REFERENCE: LISTER PART N° 351-10432

MATERIAL	
SURFACE ROUGHNESS	
TOLERANCES:-- UNLESS STATED	
ALL DIMENSIONS IN mm UNLESS STATED	
DRAWN <i>DREW</i>	RESEARCH SCHOOL OF PHYSICAL SCIENCES AUSTRALIAN NATIONAL UNIVERSITY
DATE 07-08-86	LUBRICATING OIL STRAINER-MODIFIED
CHECKED G.M.	HR3 LISTER ENGINE CONVERSION
APPROVED	SCALE 1:1 DRAWING No HR3 001

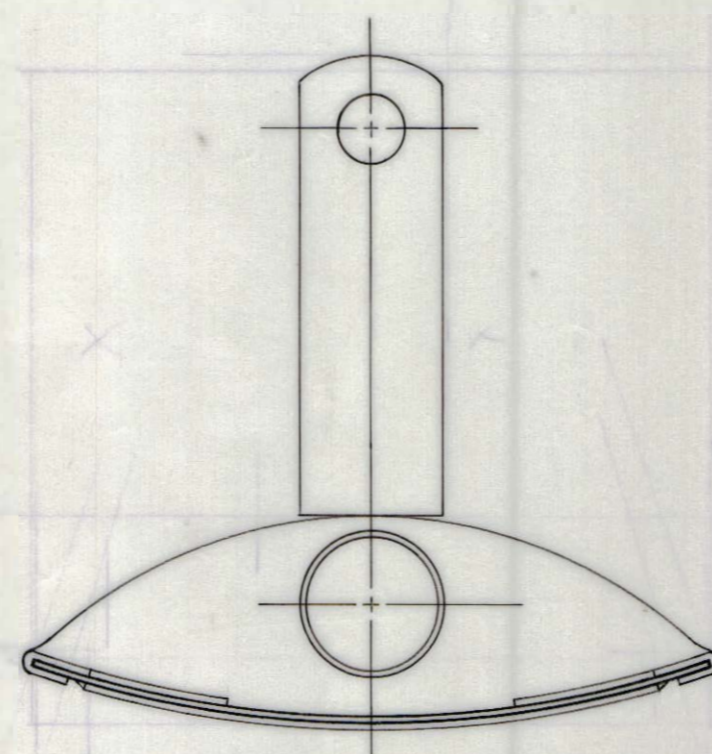
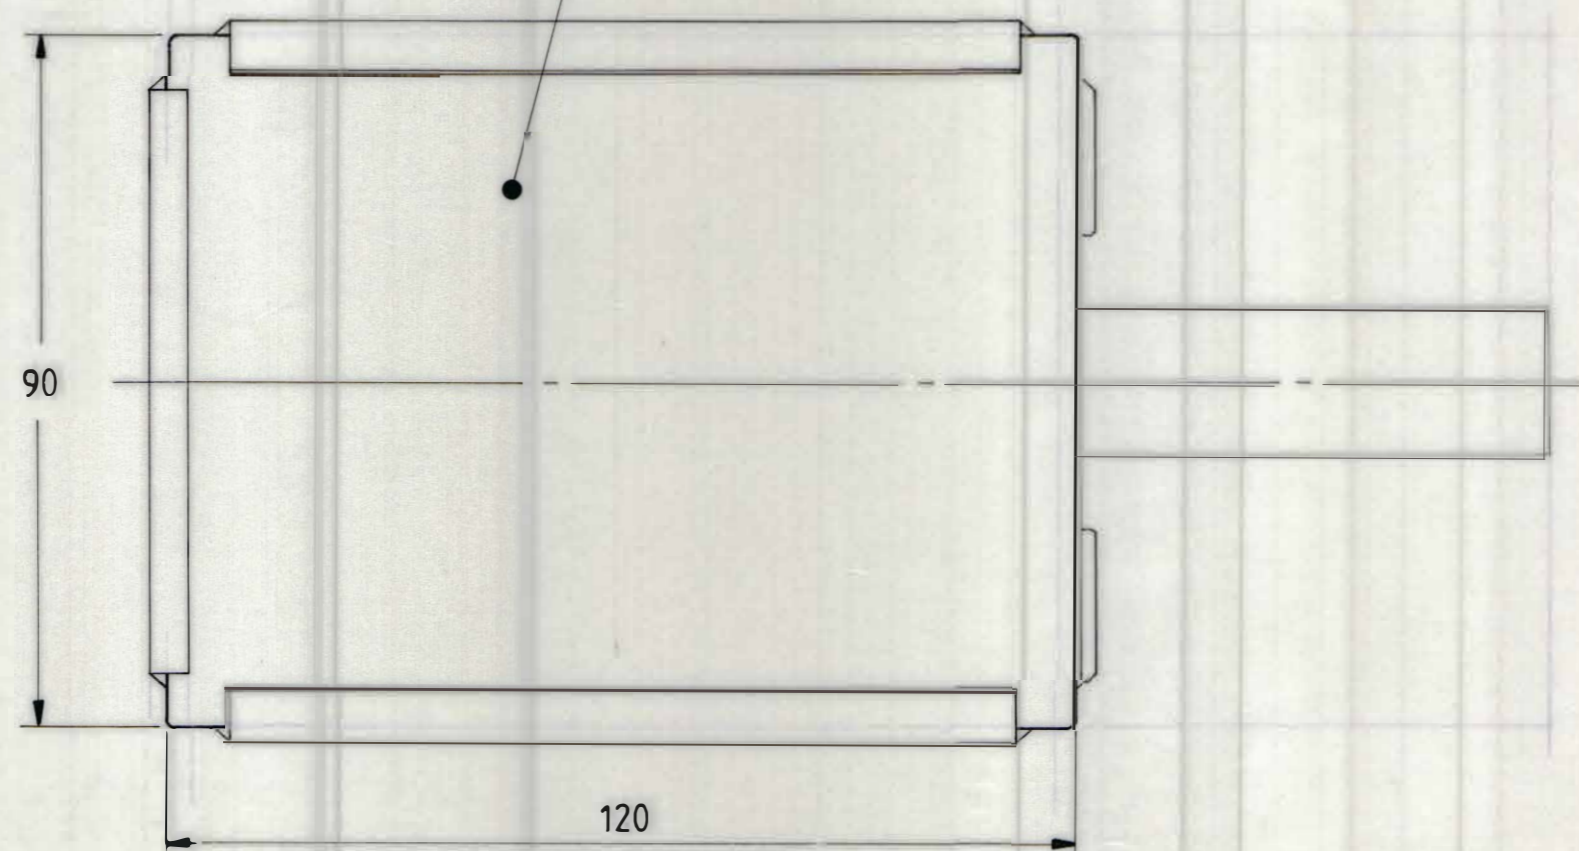
REPLACE EXISTING GAUZE BOTTOM WITH 1.2 M.S. SHEET. SEAL EDGES BY BRAZING.
